**Staff Report to the
Municipal Planning Board
June 21, 2022**

CUP2022-10003

CUP FOR RESTAURANT/BAR IN I-G/T/PH ZONING

Site Plan and Parking Layout

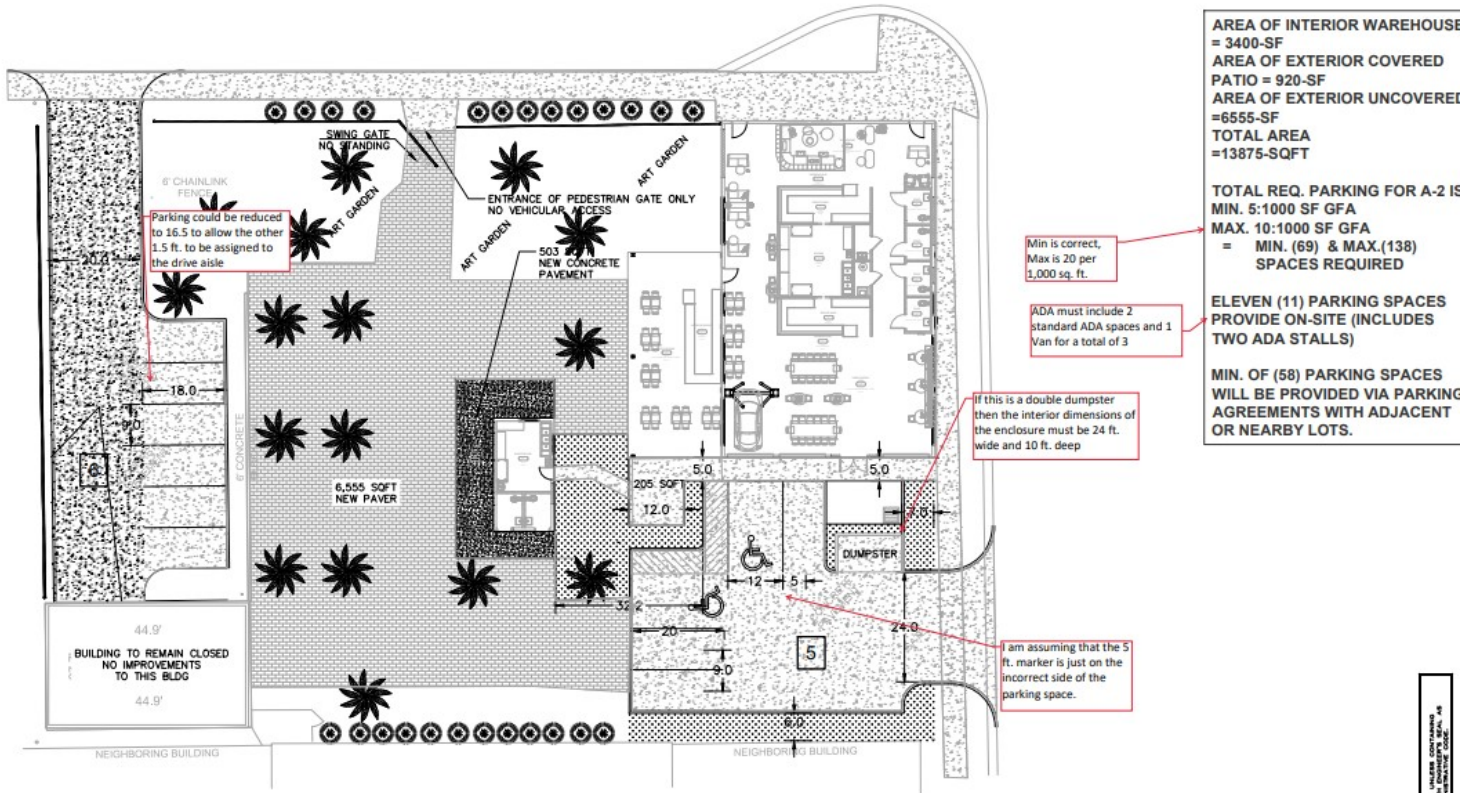
5. Solid Waste: The final site plan must show the location and size of the on-site double solid waste compactor(s) / dumpster(s) with concrete pads, and enclosures with doors. Dumpsters must be located to provide a minimum 50 feet of clear backup space and constructed per Orlando Engineering Standards Manual (ESM) requirements, or documentation must be provided from the City's Solid Waste Division indicating curb pick-up or other approved arrangement. Provisions for both solid-waste as well as recycling are required. As proposed, it appears that castered dumpsters are proposed to be used. Should the Solid Waste Division require larger dumpsters the enclosure may need to be relocated to the western portion of the property to accommodate the required backing movement. Should the dumpster enclosure move it is recommended that the current site of the dumpster enclosure be modified to include additional parking.

11. Parking Spaces: The applicant is proposing 5 on-site vehicle parking spaces where a minimum of 69 spaces are required. The applicant is proposing to meet the parking space requirements through a combination of on-site and off-site parking spaces. a. Two-wheeled Parking: A minimum of 2 two-wheeled motor vehicle parking spaces must be provided in accordance with LDC Sec. 31.322 (d). b. Off-site parking: All off-site parking spaces must meet the requirements of LDC Sec. 61.303 (b).

The refuse area should be a minimum of 12' wide by 10' deep for a single enclosure and 24' wide by 10' deep for a double enclosure. All new developments are required to have double enclosures that accommodate both garbage and recycling. The current depth of 8' should be changed to 10'. If castered dumpsters are to be used (as indicated on the plans), 14' will be sufficient for two 4-yard dumpsters to be placed sideways inside the enclosure. Please see Ch 58 of the municipality and the details section of the City's Engineering Standards Manual for more specifics.

Relocate the dumpster for access onto W Central Blvd. angle the dumpster for pickup access just north of the first parking stall.

Elevations

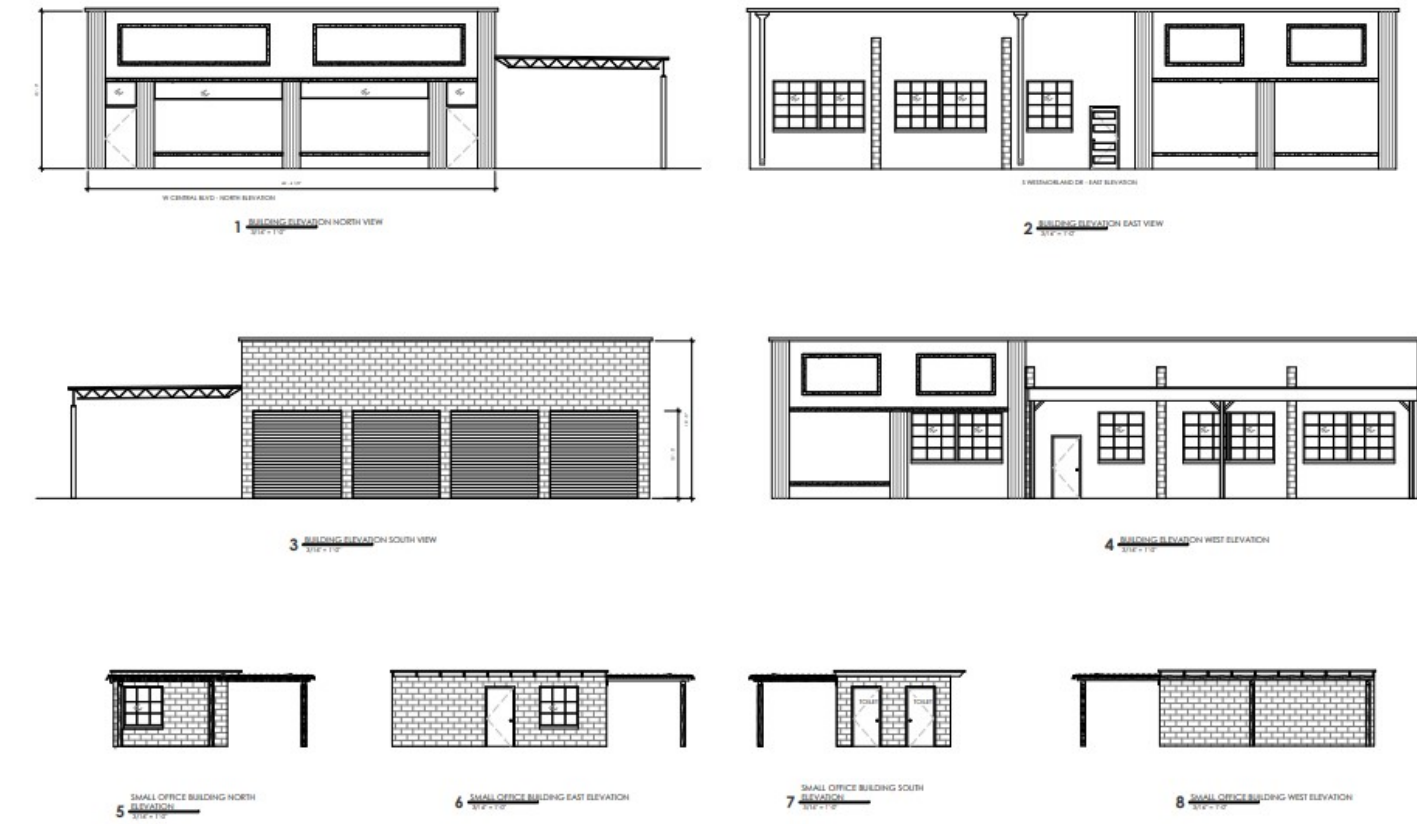
2. Staff encourages the applicant to reopen the storefront windows along W. Central, to provide enough transparency and natural light into the building.

4. Primary pedestrian entries shall be clearly expressed and highlighted.
5. Durable materials such as stone, brick, tiles or cladding must be utilized at the base of the building. Stucco is not an acceptable material.
